PROJECT: 276-278 PARRAMATTA ROAD, AUBURN
RE: CUMBERLAND DEP SESSION 02 – [November 2020]

PROJECT: 276-278 PARRAMATTA ROAD, AUBURN
RE: CUMBERLAND DEP SESSION 01 – [01.09.2020]

ADDITIONAL INFORMATION LETTER

HAMPSTEAD ROAD COMMERCIAL - STAGE 1 [19_066]

FIGURE 1: EXTRACT OF CONCEPT PLAN

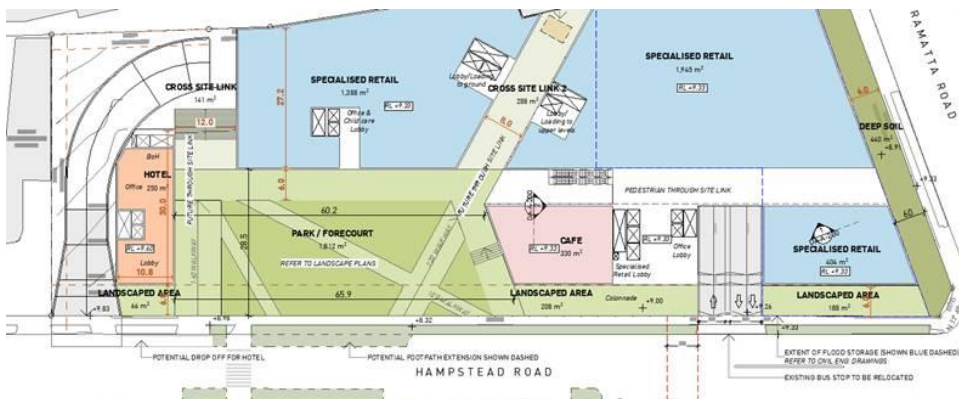
1. Alternative arrangements for accessing the basement should be explored to avoid splitting the ground floor retail and the Hampstead Road colonnade with an extended ramp. The best outcome would be the provision of a single crossover from Hampstead Road instead of two, located in a position with the least impact on the public realm and on the planning of the site, in particular the ground floor. The following possibilities could be explored:
 - a. Provision of a multi-level basement serving the entire development on the southern side of the site.
 - b. Provision of a centralised shared zone along one side of the park aligned to part, or all, of the stormwater easement which provides access to north and south basements.
 - c. Provision of a tunnel linking north and south parts of the basement from a single access point.

The Design Excellence Panel was concerned with the splitting of the basement retail and suggested a single cross over on Hampstead. They indicated a preference to provide a tunnel under the culvert to connect the two basements.

- Vehicle entry for service vehicles at the southern boundary under the hotel.
- 1 level of basement for service vehicles and loading facilities
- Vehicle entry for cars to be located 6m to the north of the King Street intersection
The car ramp can have a steeper gradient than that required for service vehicles this allows a reduced impact on the retail floor plate and allows efficient cross site connections and access to the commercial lobby and retail circulation from the park.

FIGURE 2: ALTERNATE DRIVEWAY LOCATION - NOT FEASIBLE DUE TO CONFLICT WITH STORMWATER CULVERT, FLOODING AND PEDESTRIAN CIRCULATION

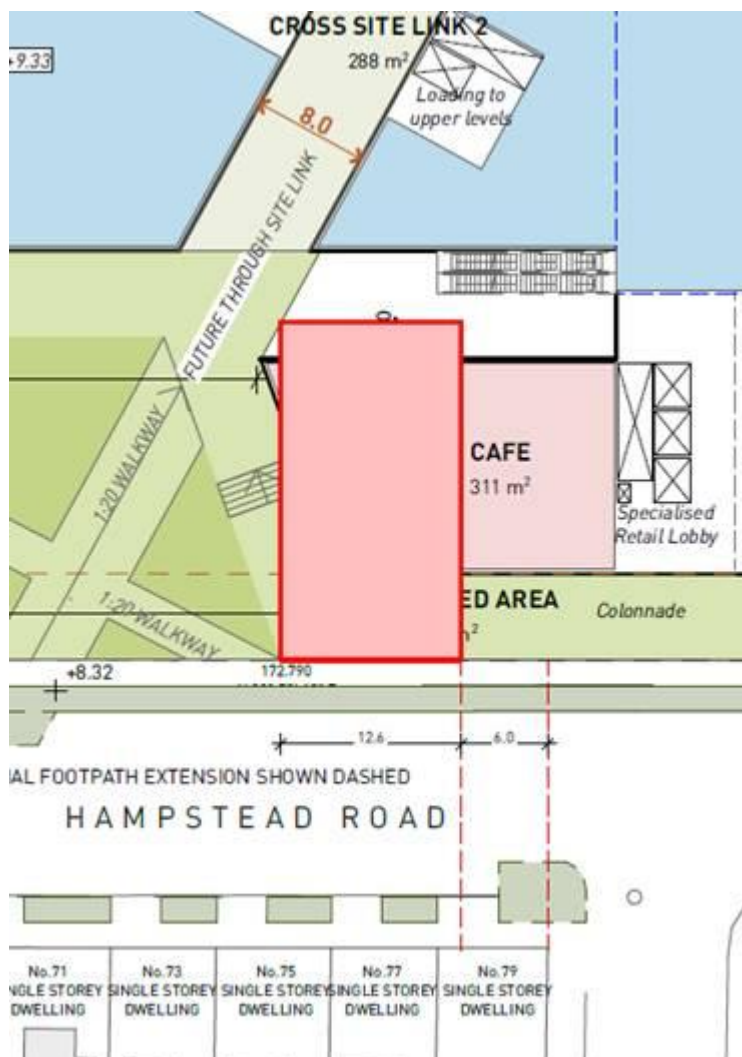
A driveway location was also explored to the south of the King Street intersection, however a driveway in this location will conflict with the flood storage strategy, the existing culvert and will provide a barrier at ground floor that will not enable pedestrian access to form the open space to the retail.

FIGURE 3: SECTION AT CROSS SITE LINK

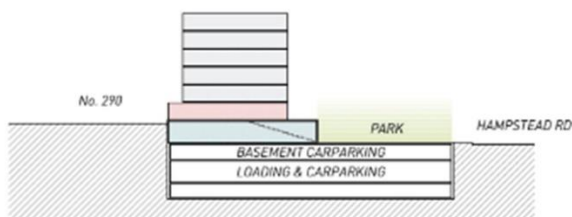
9. Further consideration should be given to the relationship between the proposed site links and both current and future neighbouring context to provide safety, security and connectivity.

The drawings have been amended to provide clarification with respect to the change in level between the subject site and the adjacent site. Stairs will be provided to enable the pedestrian connection. This also allows alternate access to the child care centre and hotel at this upper level.
